CEDAR CREEK SOUTH
PRELIMINARY OVERALL AREA DEVELOPMENT PLAN

POADP # 286 - B

The City Staff Development Review Committee has reviewed Cedar Creek South Subdivision Preliminary Overall Area Development Plan # 286 - B. Please find enclosed a signed copy for your files. Although your plan was accepted, please note the following:

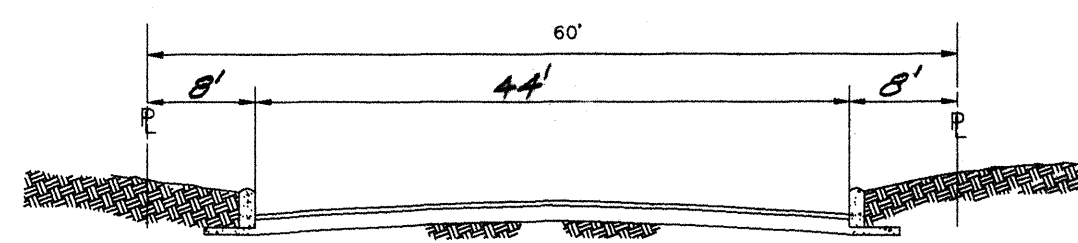
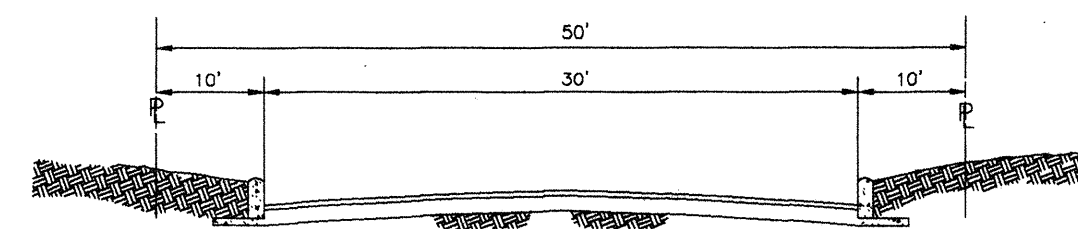
- Based on the topography, a Flood Plain Study and drainage review will probably be required during the platting process.
- In consideration of public safety and convenience, excessive grades by reason of topography should be avoided in street layouts and arrangements.

- A 1' non access easement will be required for the lots backing onto the 60' local type B Street
- It will be expected that you will plat all of the property depicted in your POADP, to include: floodpains, drainage areas and open space.

run road parallel to flood plain so that neighbors can enjoy a park

* recommend a second entrance to to POADP small corner area.

- Aquifer
- trees
- slope note
- drainage
- TIA / #286
- 1' non access easement
on lots backing onto
60' local type B street
- median modification
req. @ subdivision
entrance.
